Dimension Changes, Douglas Avenue

STREETSCAPES
PROJECT NAME

DOUGLAS AVE. STA. 48+00 TO 53+00
SHEET TITLE

Sheets 7, 8, & 9

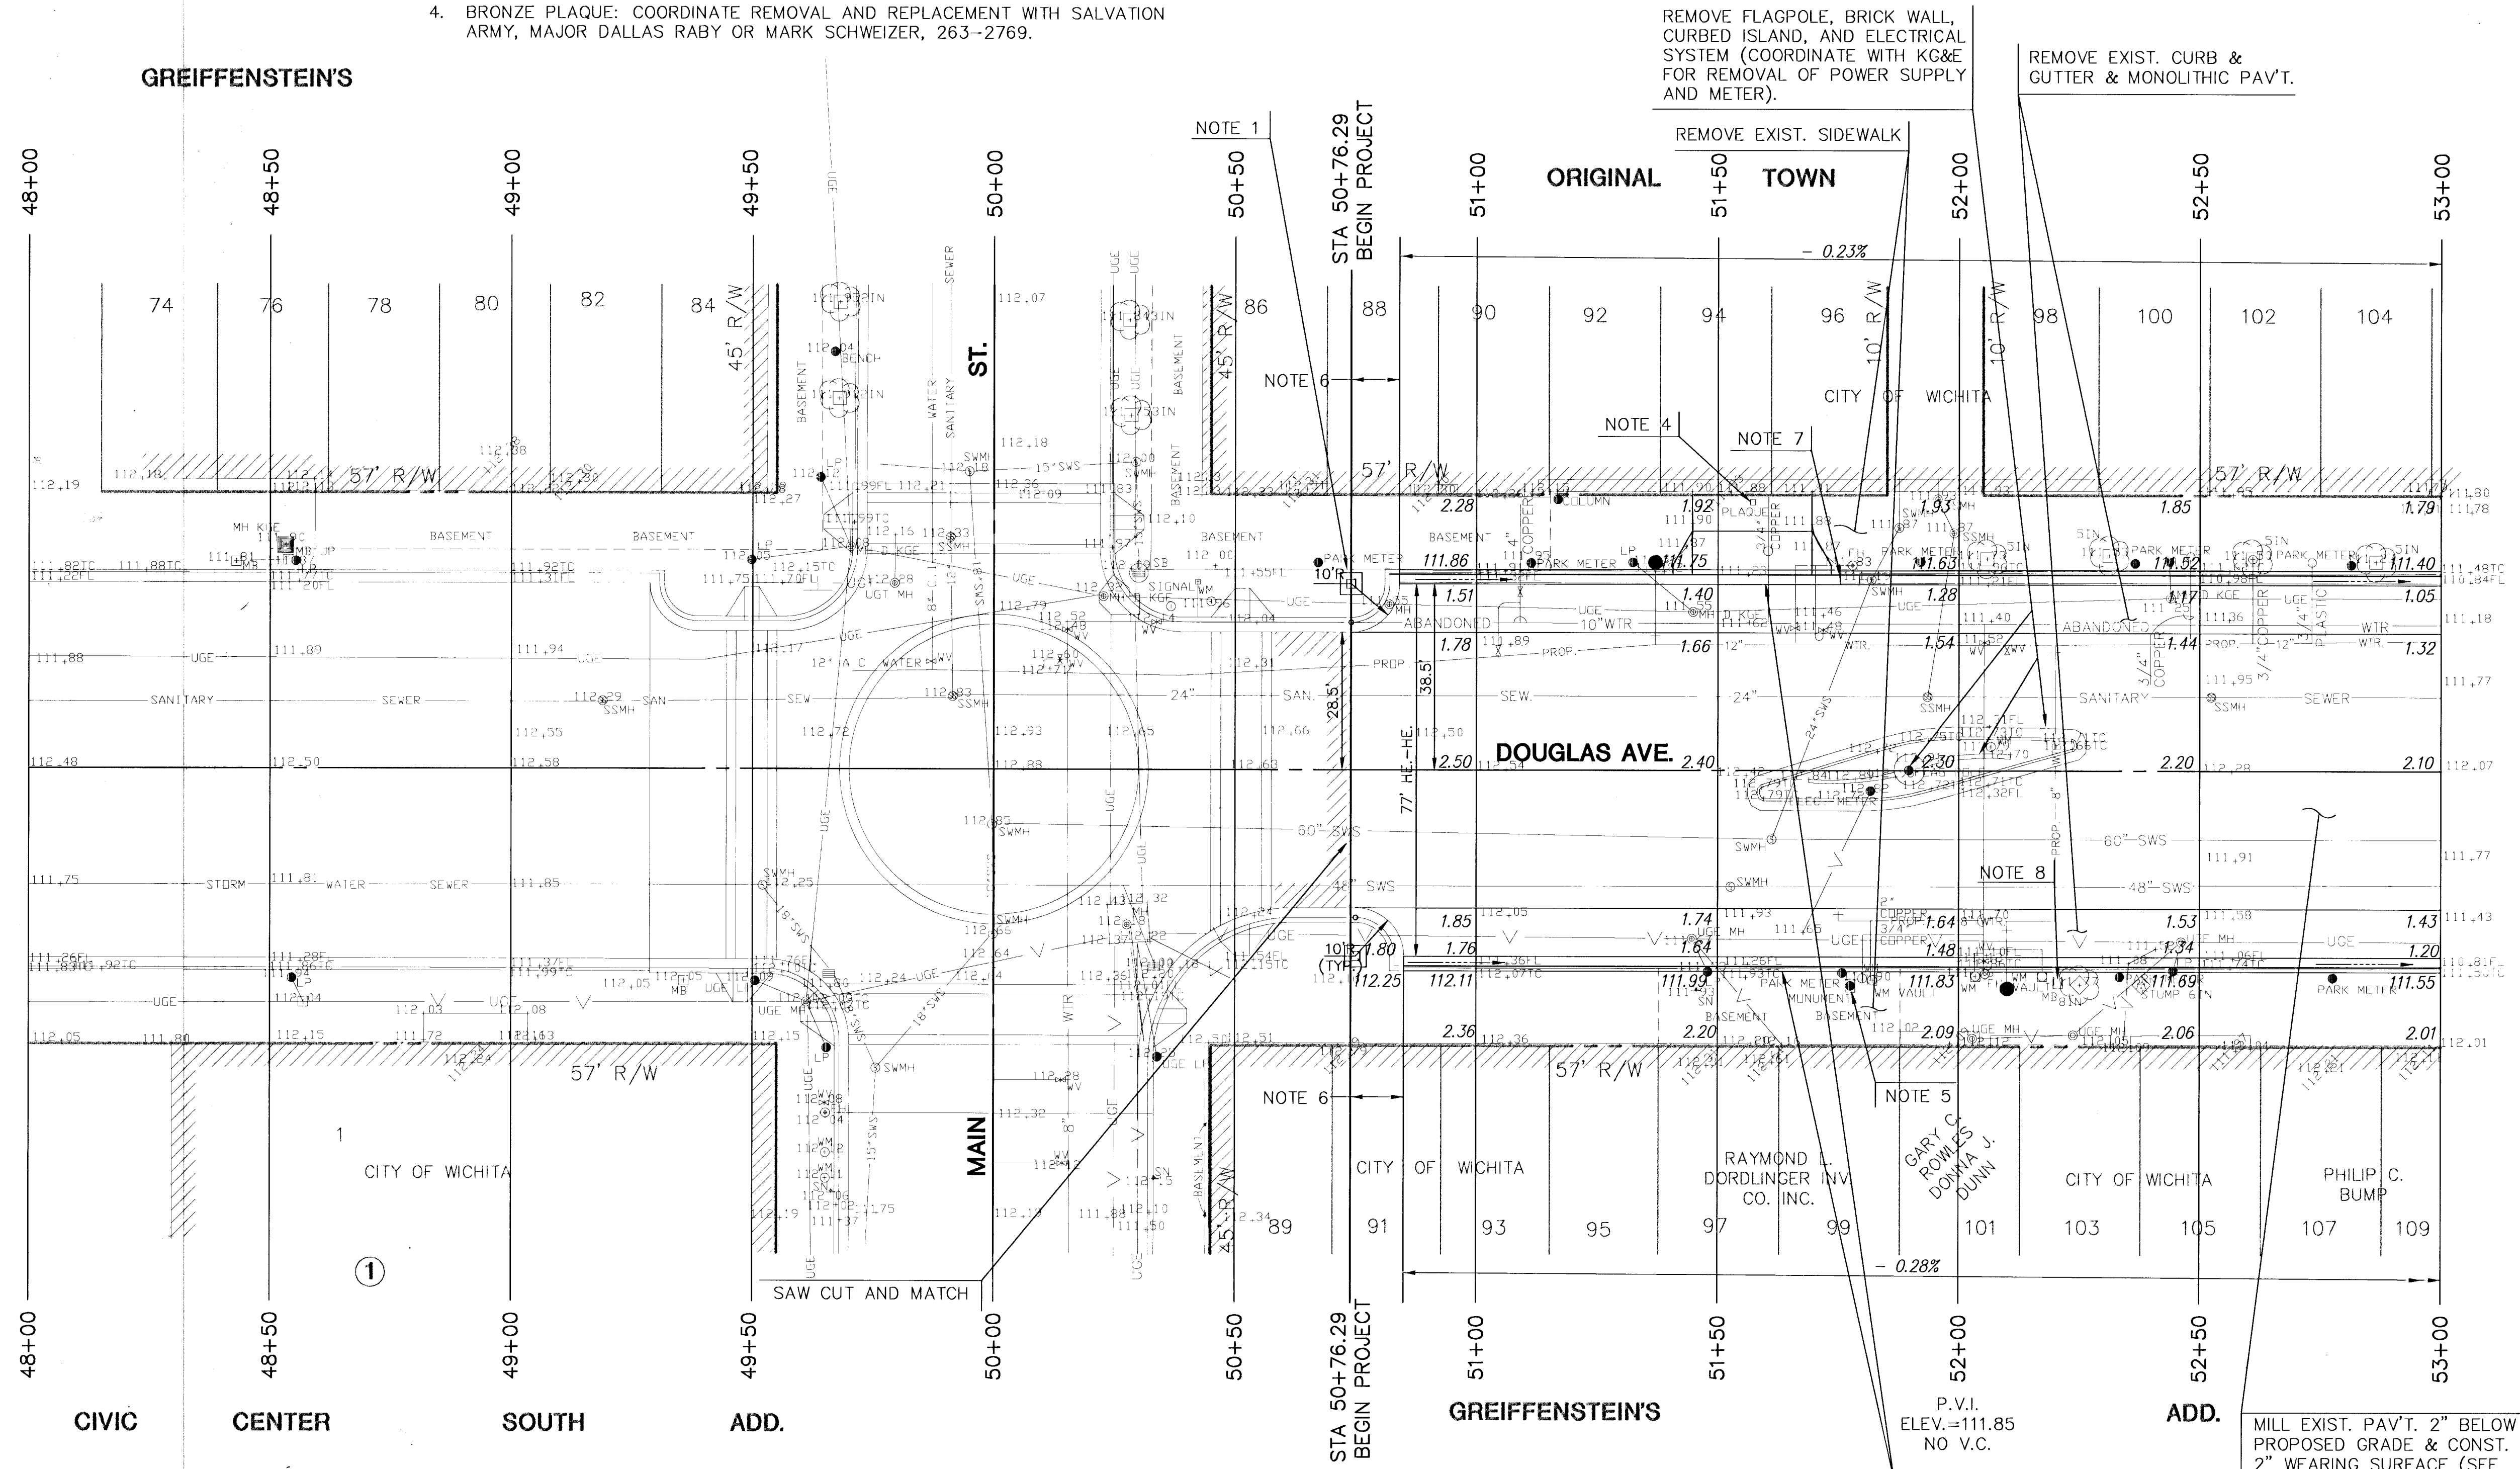
Sta. 50+85R to Sta. 53+10R
Sta. 58+26R to Sta. 60+55R
Sta. 54+55R to Sta. 56+78R

Plans show 38.5' centerline-H.E. Change to 37.5' centerline-H.E. South curb to clear street light foundations, and as approved by the Engineer. Adjust locations of curb inlets Lines 1B, 2B and 3D accordingly.
